Subject: South Fork Quitchupah 2R2S, Canyon Fuel Company, LLC, Sufco Mine,
C/041/0002, Task #3950

Deficiency List

Task Name: South Fork Quitcupah 2R2S

RE: South Fork Quitchupah 2R2S, Canyon Fuel Company, SUFCO Mine, Permit # C/041/0002, Task #3950

Flow data from the S. Fork of Quitchupah

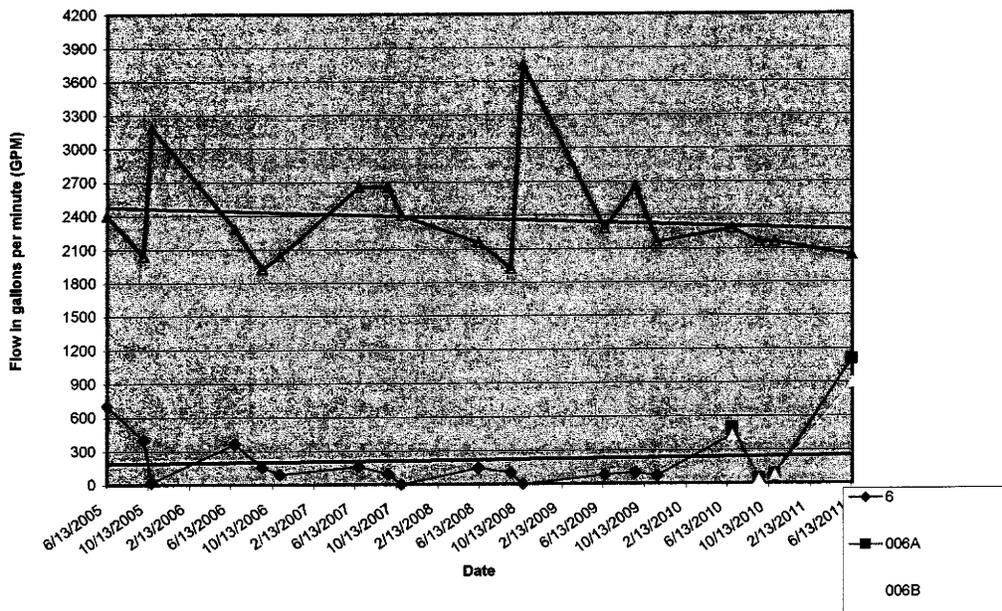
Currently, there are three surface water sampling locations monitored on a quarterly-basis along the south fork of Quitcupah Creek. Surface water sample location SUFCO 006 has been a historical stream monitoring location since June 1983. Two additional water monitoring points SUFCO 006A and 006B were added to the plan in June 2010. A third surface water sampling location is proposed for addition to the plan SUFCO 006C as part of this submittal. This location is intended to represent the downstream conditions. A mine water discharge outfall (UT-0022918-003A) is located approximately 1.5 miles further downstream and discharges water at an average constant rate of 6.75 cubic feet per second (cfs). Maximum flow rates from the South Fork of Quitcupah Creek reported from data point SUFCO 006 have been reported as 2 cfs (Table 7, Quitcupah/Muddy Creek CHIA Nov 2010). By comparison, the groundwater

discharge from the outfall location discharges at rates 12 times greater than the discharges rates measured upstream at SUFCO 006 (see graph below). Locations of these surface water sample locations are shown on Plate 7-3 of the SUFCO MRP.
